Addendum No. 02

Subject: Allen M. Stearne K-8 School – Fire Alarm System Replacement
SDP Contract No. B-084C of 2018/19

This Addendum, dated April 15, 2021, shall modify and become part of the Contract Documents for the work of this project. Any items not mentioned herein, or affected by, shall be performed strictly in accordance with the original documents.

DRAWING NO.
E - 001.0
SHEET 1 OF 11

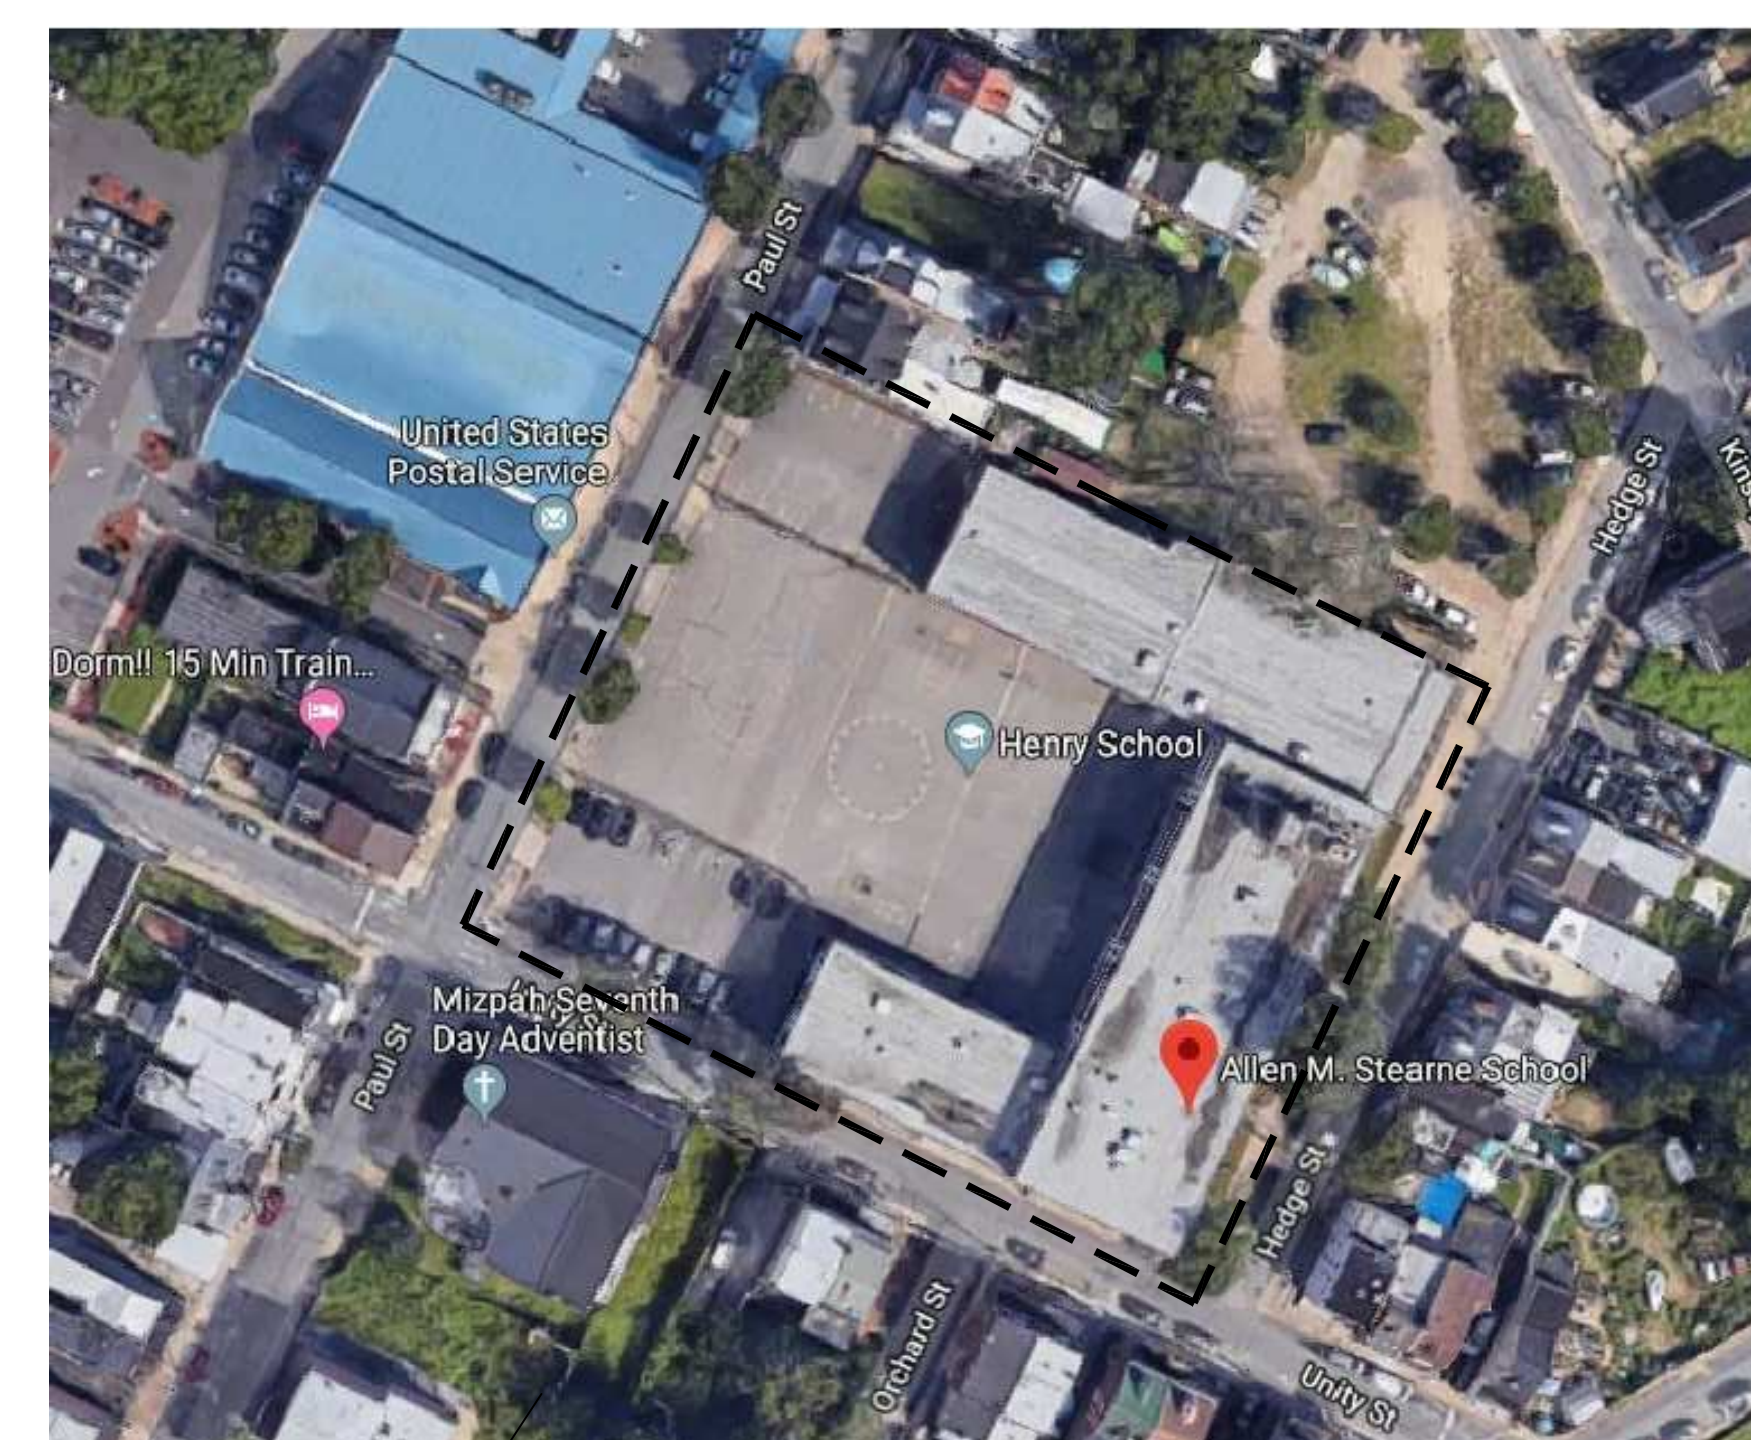
E001:

1. Added the digital voice command symbol (DVC).

DRAWING NO.
E - 101.0
SHEET 7 OF 11

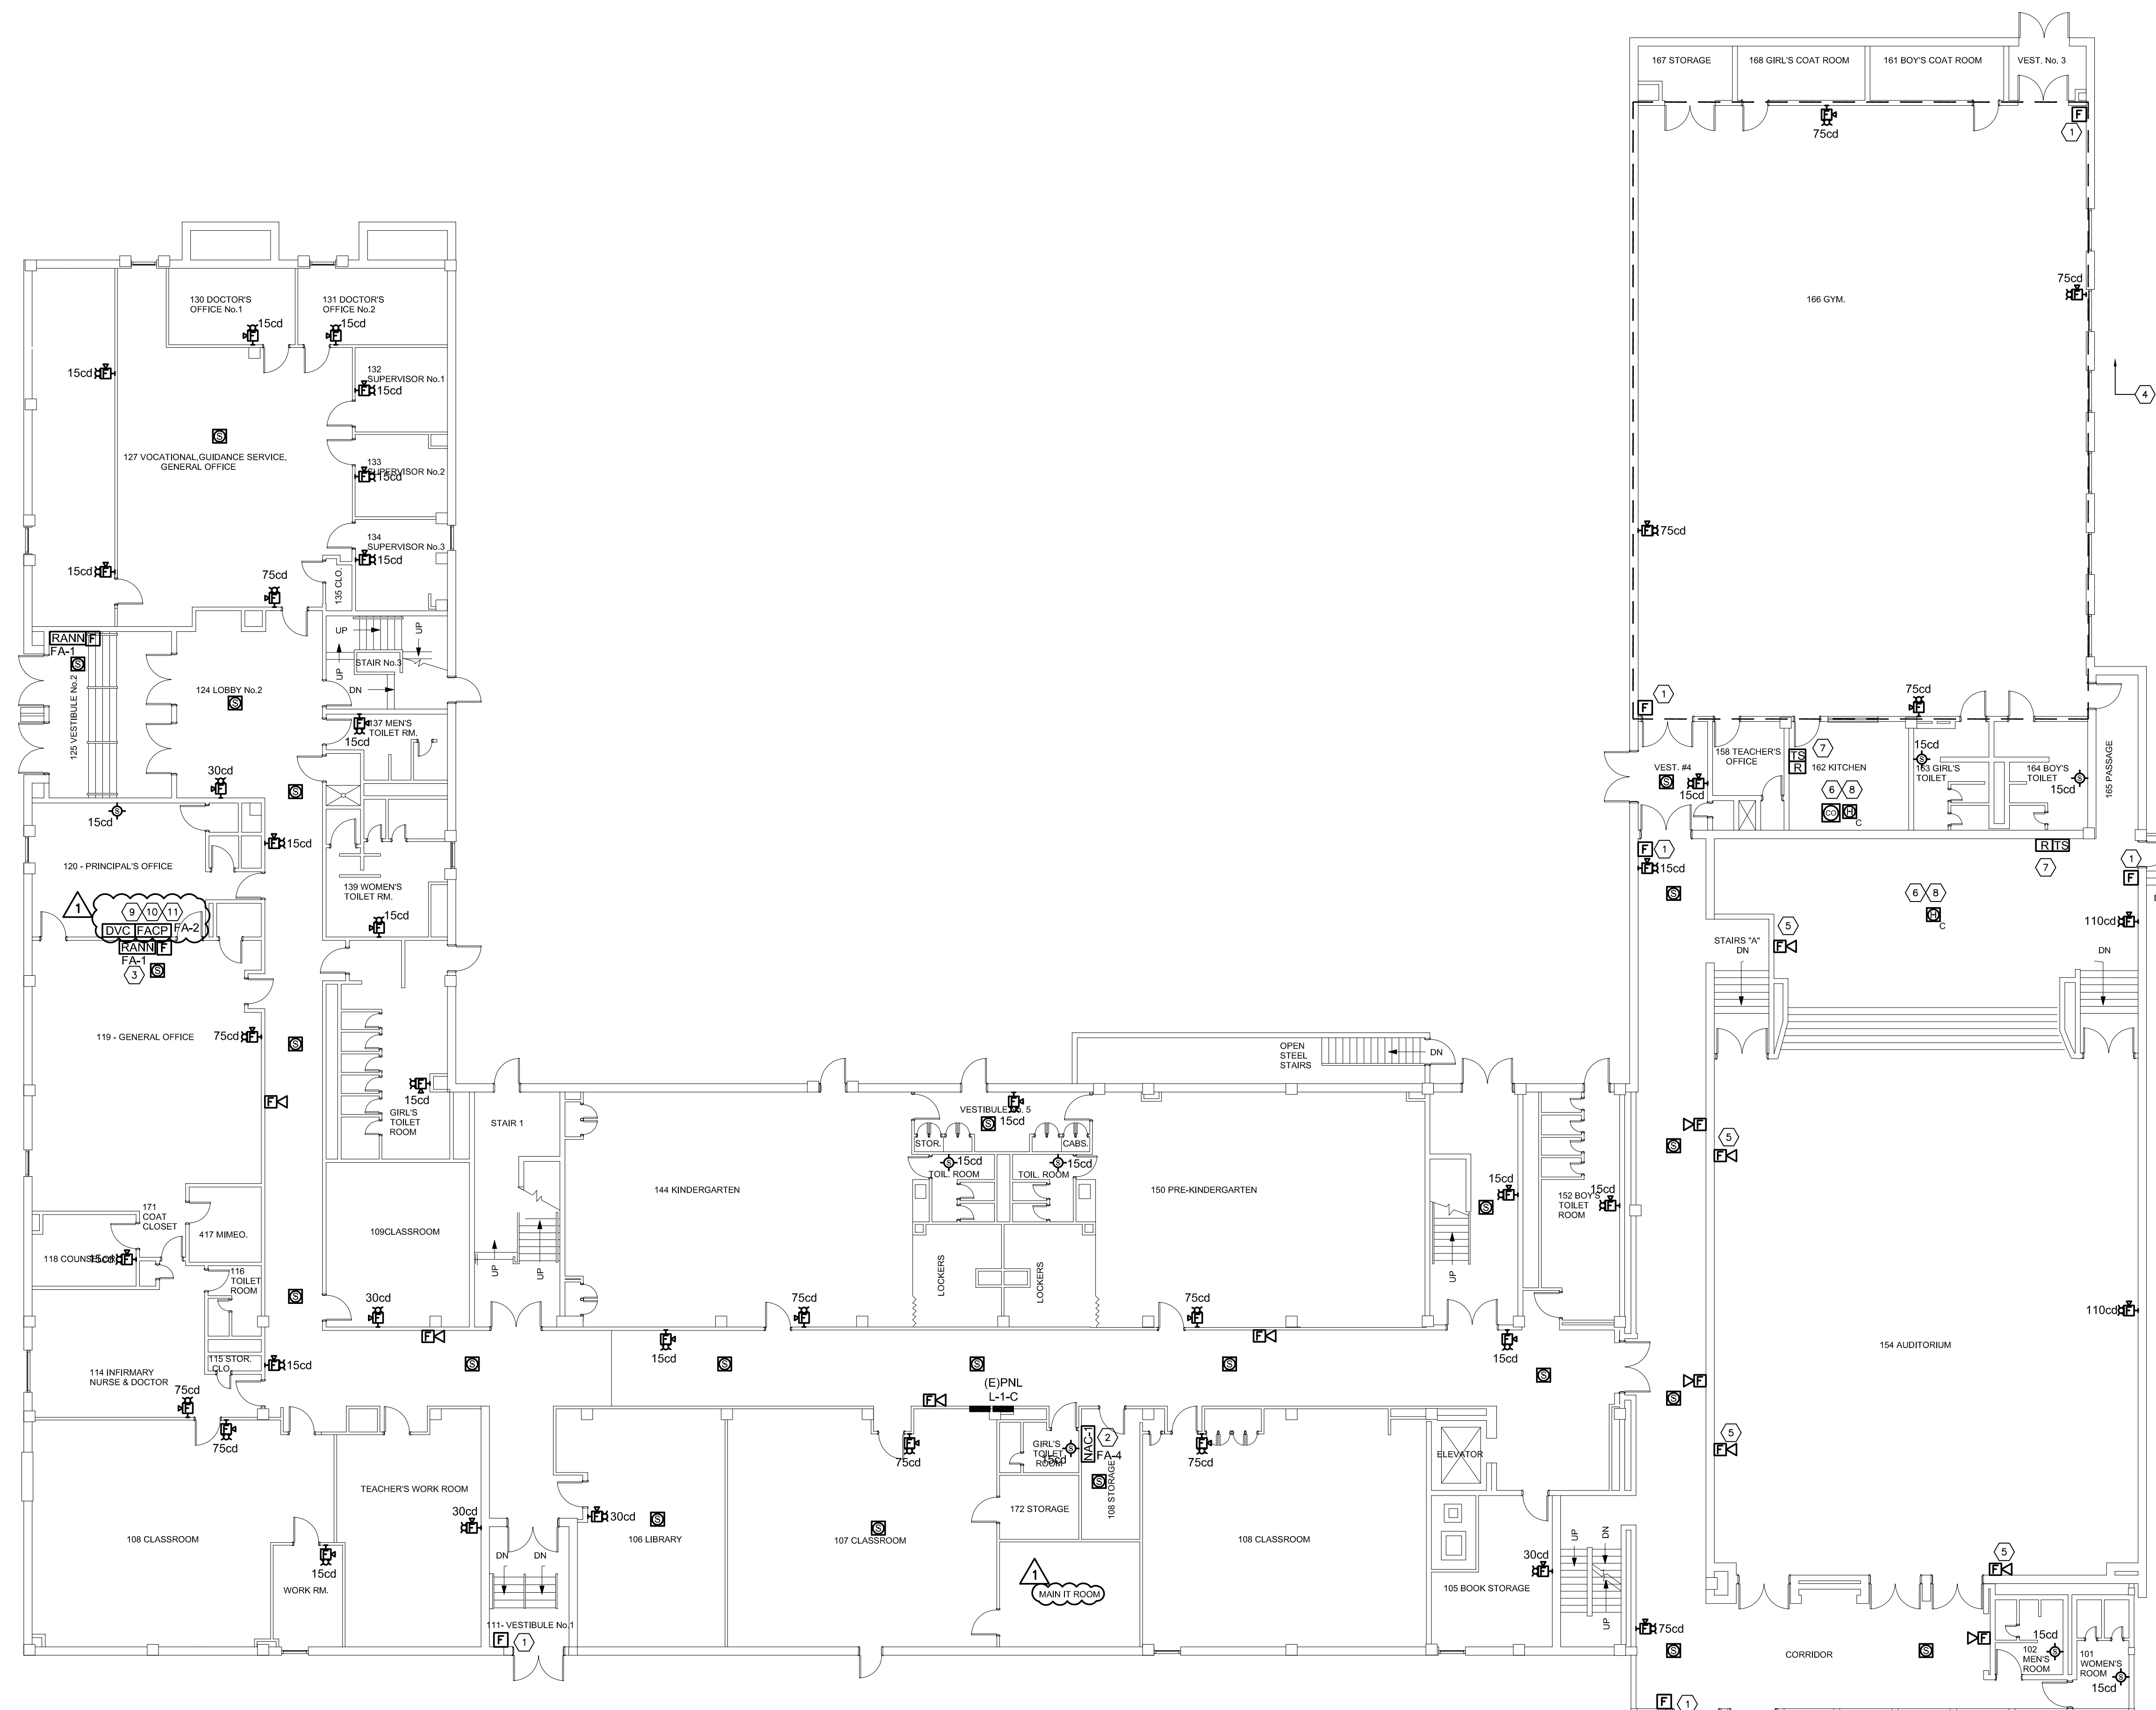
E101:

1. Relocated FACP to the Principal's office, added DVC adjacent to FACP and identified Main IT room (telephone demarc location).

Question #7: Per keynote 3 on drawing E-100.0, the EC is to provide cat 6 cabling from the FACP to the main IT rack (there is a similar note on the riser diagram E-601.0). Please confirm that we should terminate at the telephone demarc instead of the main IT rack. Please indicate in plan where the telephone demarc location is, as the room is currently not indicated on the drawings.

Question #13: On Drawing E-101.0, the remote annunciator is shown to be installed where the existing Simplex Clock system is located. Is this correct?

Response – See revised drawing E101 for main IT room/demarc location.

Response – Install a remote annunciator and a pull station at general office 119, per school district construction manager's field instruction. Include 100 feet of additional conduits, conductors and labor in the base bid for the potential new locations.

DRAWING NO.
E - 601.0
SHEET 10 OF 11

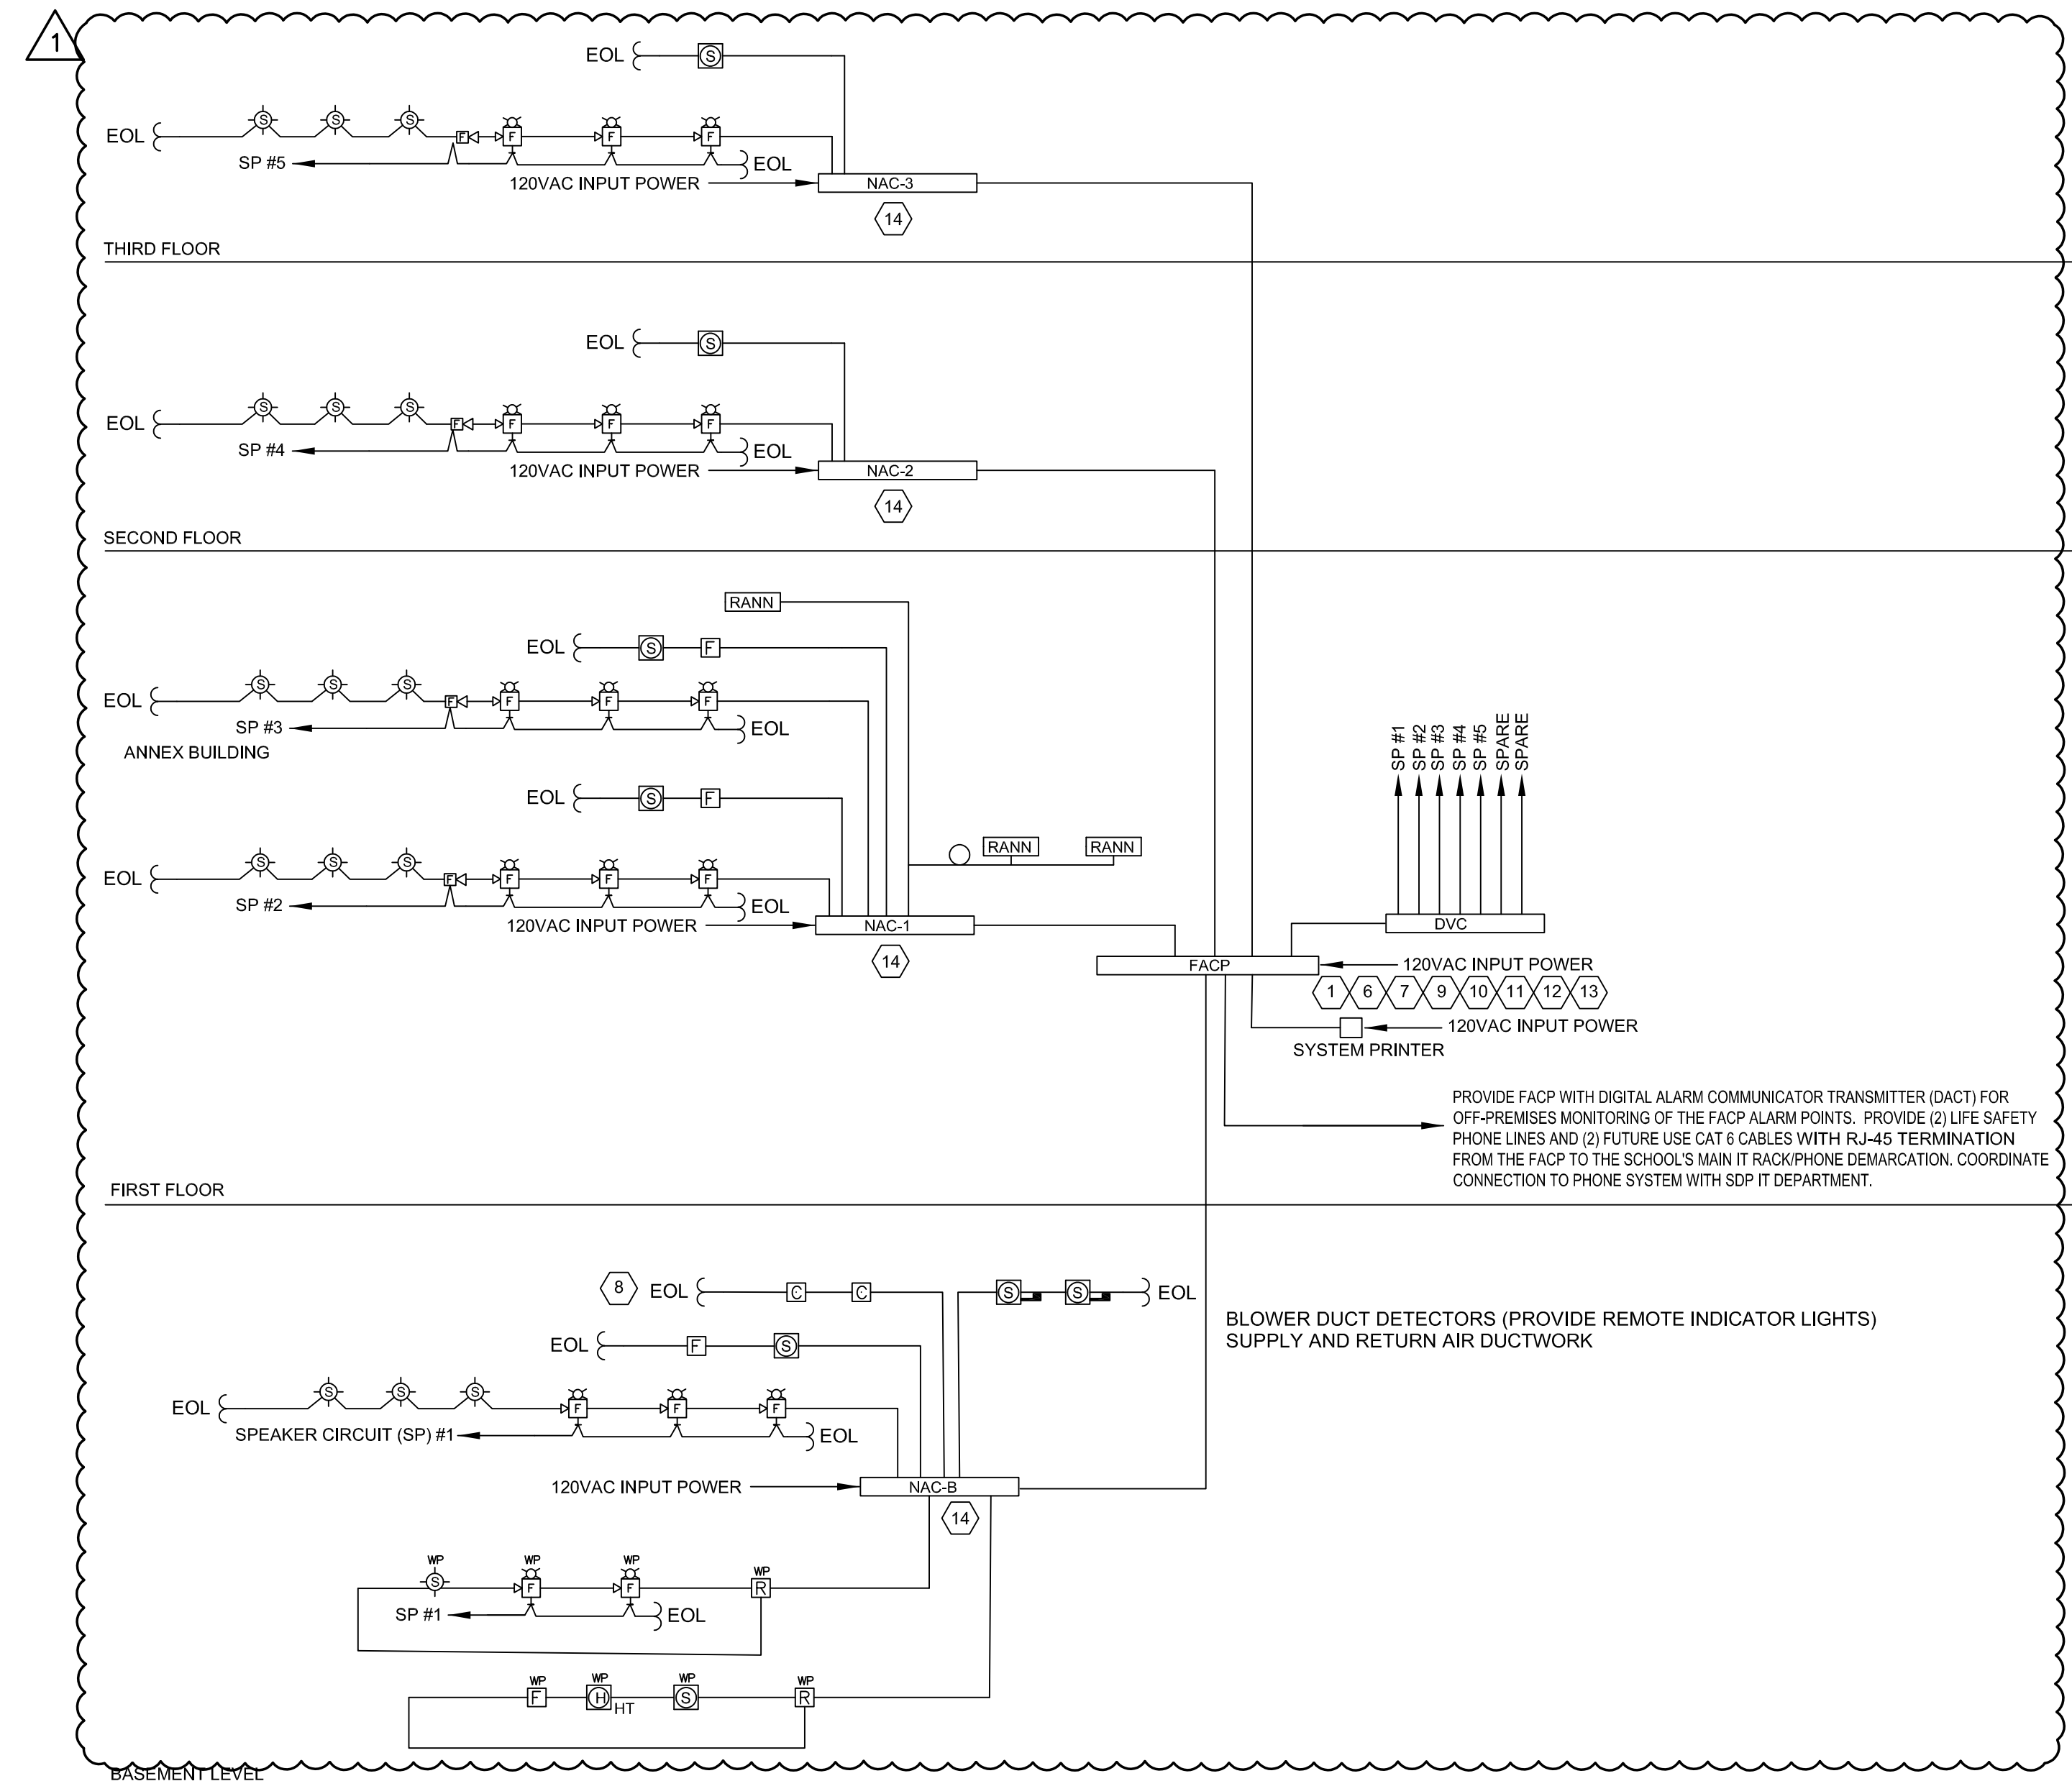
E601:

1. Drawing removed antenna, add digital voice command and updated riser diagram to reflect a voice evacuation fire alarm system. Updated spare devices/equipment quantity.

Question #8: There are discrepancies on the fire alarm riser diagram on drawing E601.0. The wiring shown in the diagram does not appear to be how fire alarm voice systems are typically wired. A voice system is specified, but this riser does not show voice cabling. It appears to show horn wiring. Additionally, voice circuits and annunciator circuits cannot generate from a NAC panel. Also, is an audio notification system panel required? Please clarify this design.

Question #9: Please confirm an antenna as shown on the fire alarm riser diagram on drawing E601.0 is **not** required for this project. If required, please provide location, specifications, and cabling requirements.

Response – See revised riser diagram for a voice evacuation fire alarm system.

Response – Antenna is not required for this project. See revised riser diagram.
